STATE OF NORTH CAROLINA
DEPARTMENT OF TRANSPORTATION

Subject: **Submittal of DCM Consistency Certification** for the proposed US 17 Improvements
From the Jacksonville Bypass to Drummer Kellum Road Jacksonville, Onslow County,
TIP U-4007, WBS 35008.1.1

Coastal Zone Consistency Certification Supporting Information for the NCDOT's Request to Construct the US 17 Improvements from the Jacksonville Bypass to Drummer Kellum Road of the City of New Jacksonville, in Onslow Counties (US 17 Improvements). NCDOT TIP U-4007.

Subject: Minutes from Interagency 4C Permit Drawing Review Meeting
On April 15, 2009 for U-4007A in Onslow County

SITE 3

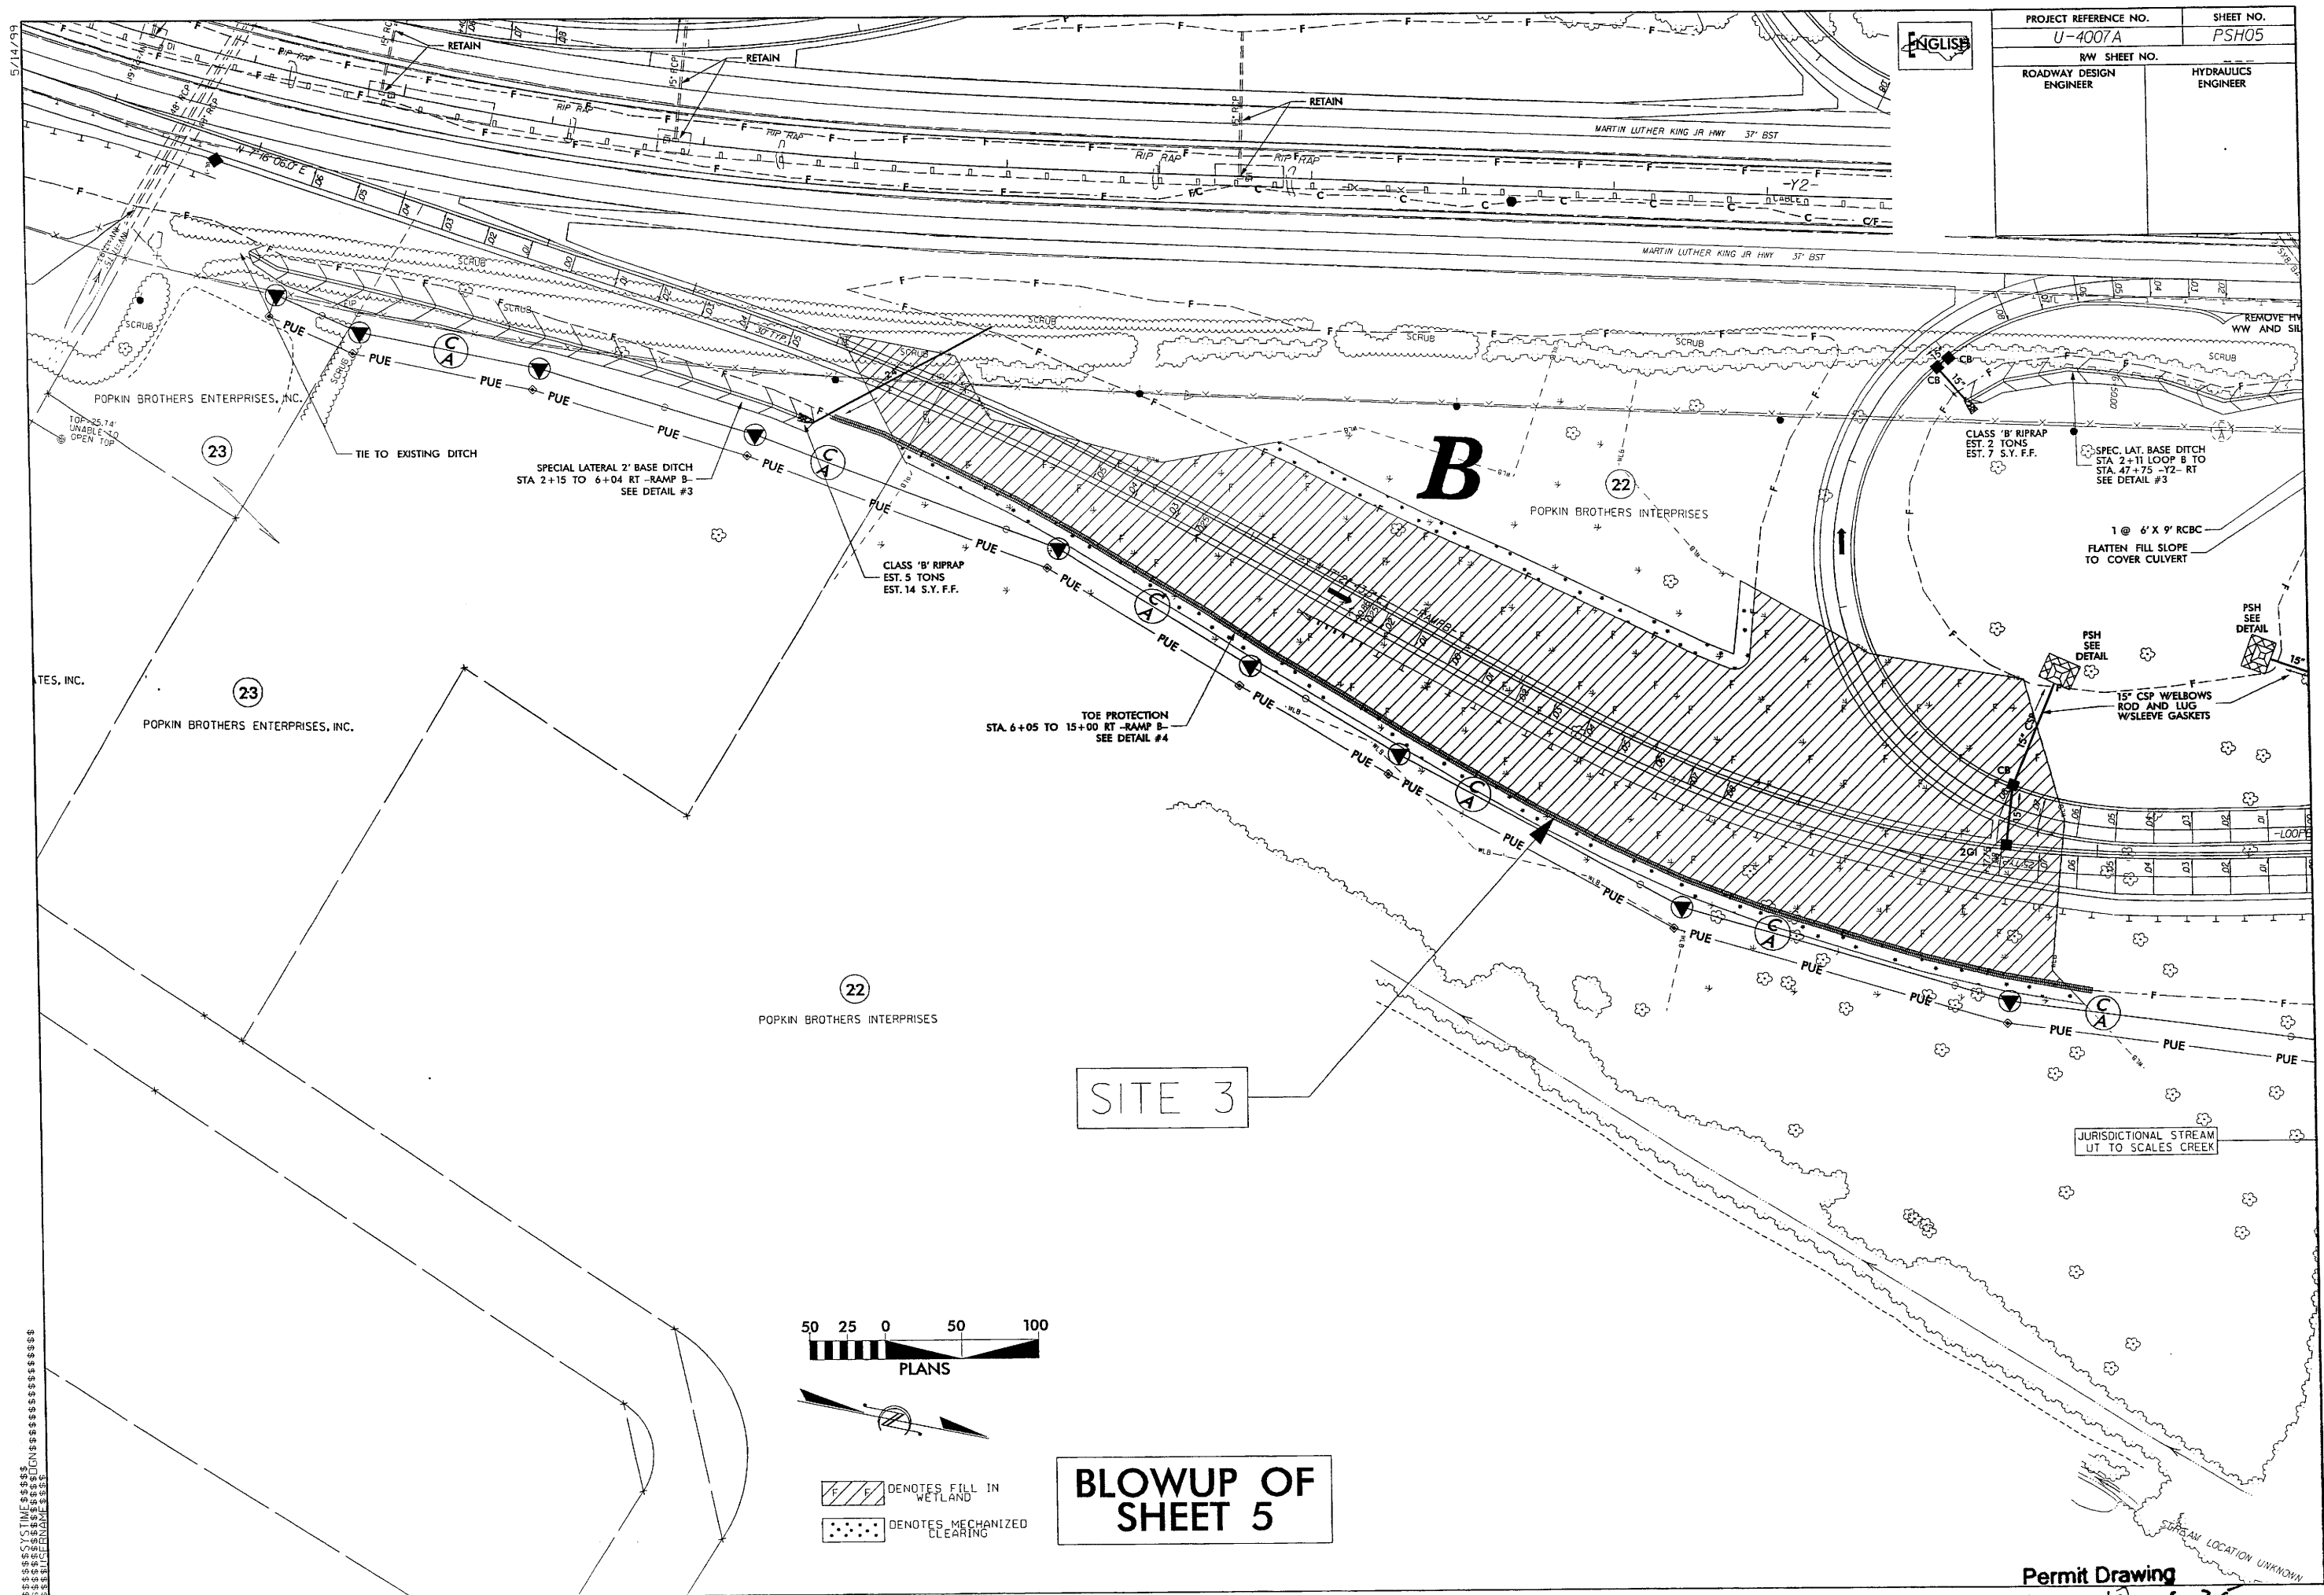
Mr. Dalton noted that there is a large wetland impacted by the proposed Ramp B. There was a discrepancy in the wetland limits. The plan sheet that contained the enlarged view of the site showed the wetland closed off adjacent to the proposed right-of-way line. The plan sheet that shows the entire interchange showed the wetland continuing away from the project limits. Mr. Rivenbark and Mr. Merritt stated they would verify the correct wetland limits. Mr. Shaver stated that if the wetland was closed off and did not continue away from the project, the remaining
